### **REMARKS**

**AMENDMENTS TO THE DRAWINGS**

Application S/N: 10/699,779  
Docket No. P03344-USDIV  
CLO.002DIV

FIG. 29

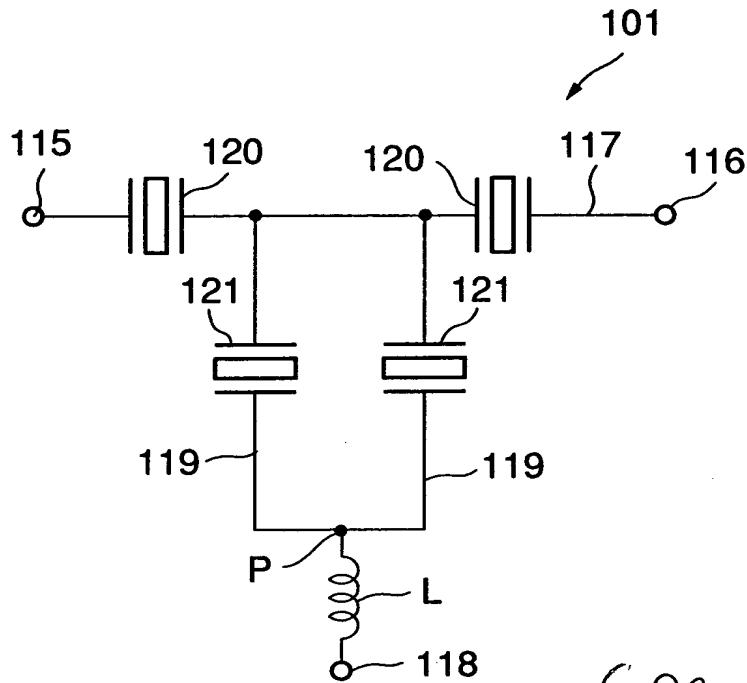
The attached drawing sheet includes a change to Figures 29-35 to add the "Prior Art" label, as requested by the Examiner.

The Examiner has objected to Figures 29-35 for failing to include a "Prior Art" label. Applicant includes a drawing revision identified above to address this concern.

(PRIOR ART)
